REVISED RESPONSE TO REQUEST FOR ADDITIONAL INFORMATION**APR1400 Design Certification****Korea Electric Power Corporation / Korea Hydro & Nuclear Power Co., LTD****Docket No. 52-046**

RAI No.: 274-8277
SRP Section: 7.1 - Instrumentation and Controls
Application Section: 7.1, 7.3, and 10.2
Date of RAI Issue: 10/27/2015

Question No. 07.01-40

Figure 7.2-4 CEA Position Signal Flow for CPCS

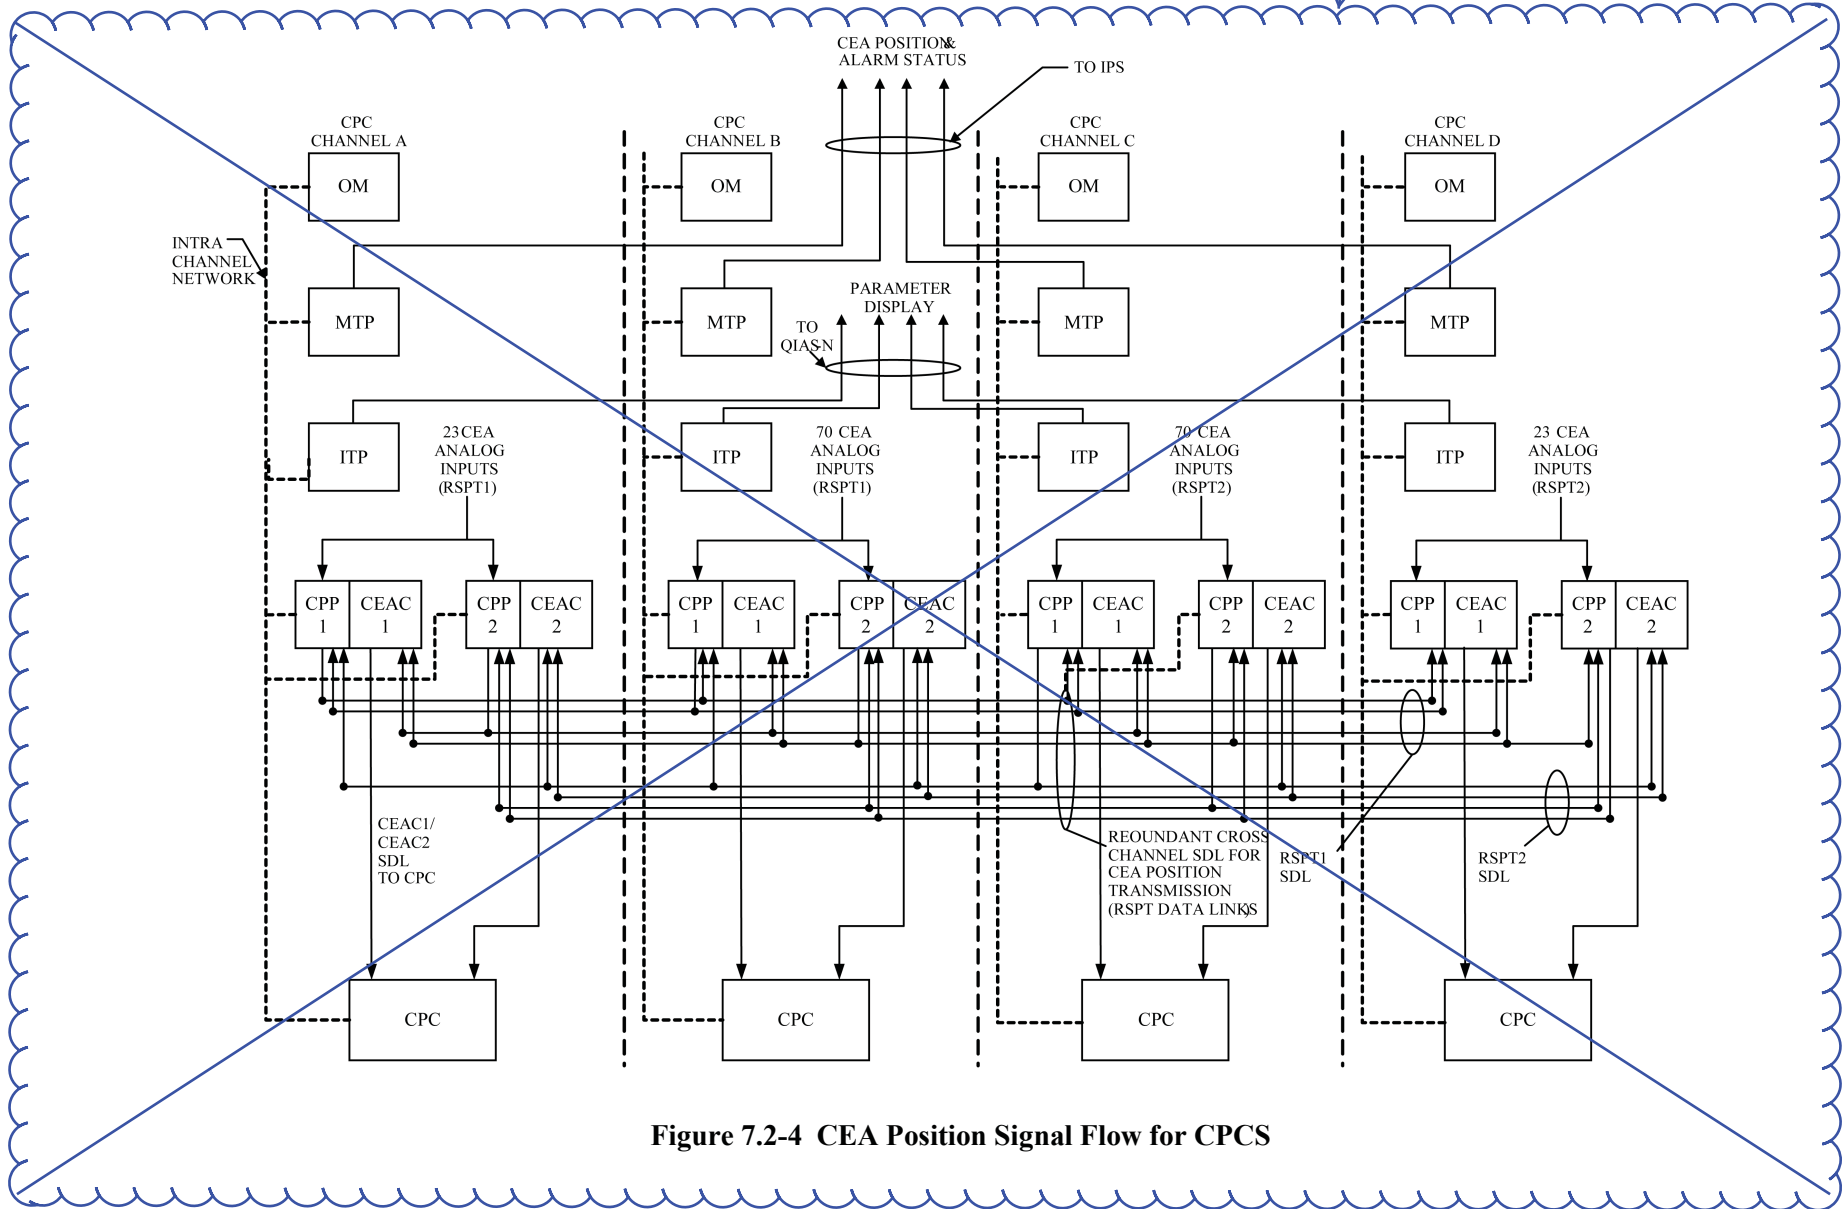
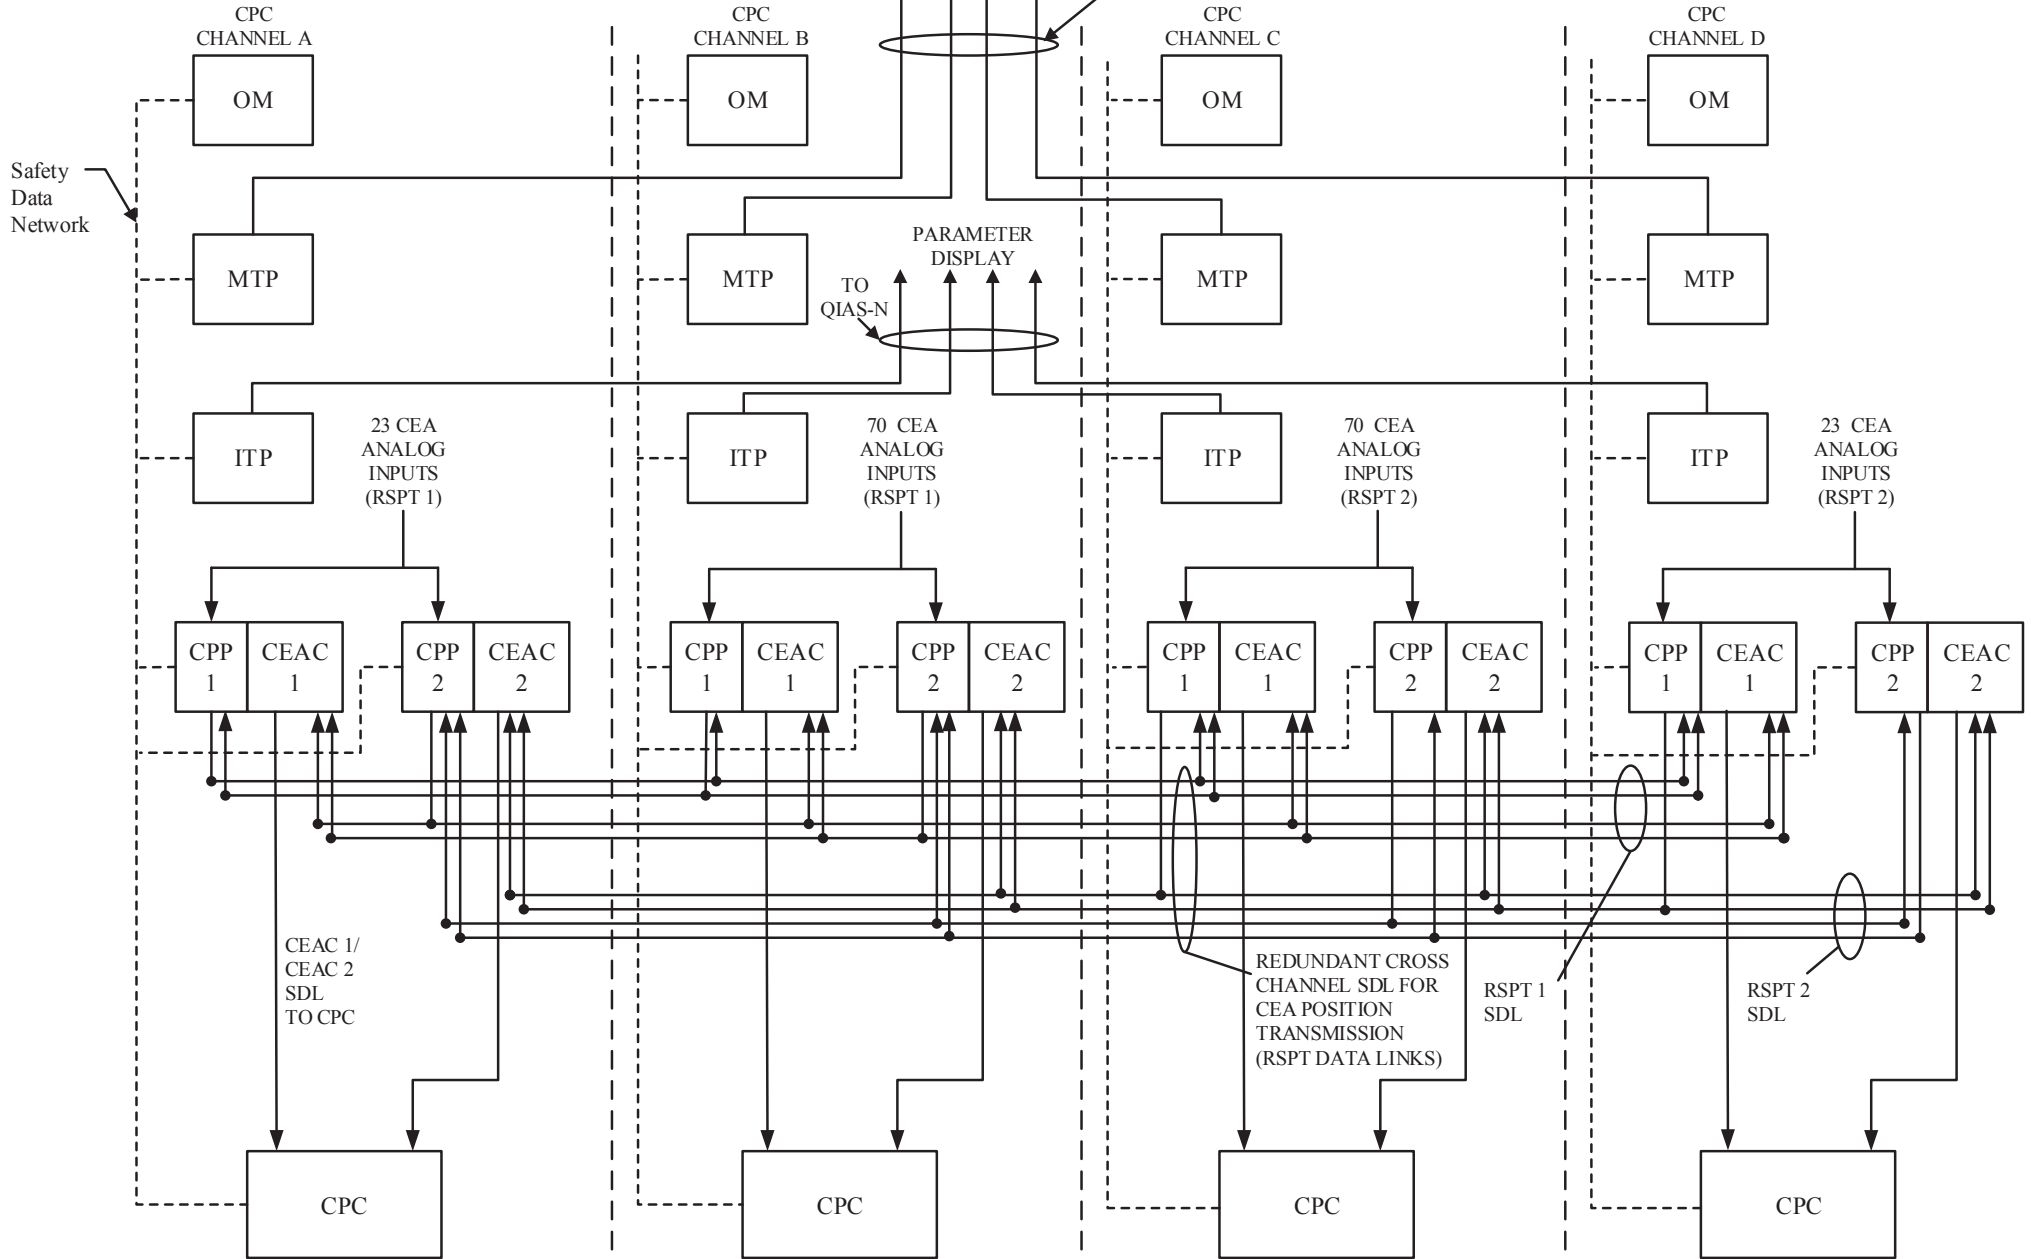
In addition, DCD Tier 2, Figure 7.2-4, “CEA Position Signal Flow for CPCS,” will be modified because it was missing a CPP output signal from the Channel D CPP1 module.

The correction made to the diagram for the input to CPP2A in this revised supplemental response also supersedes the diagram supplied in RAI 50-7911 Question 07.02-08 (ML15265A591).

The figure will be replaced with the next page.
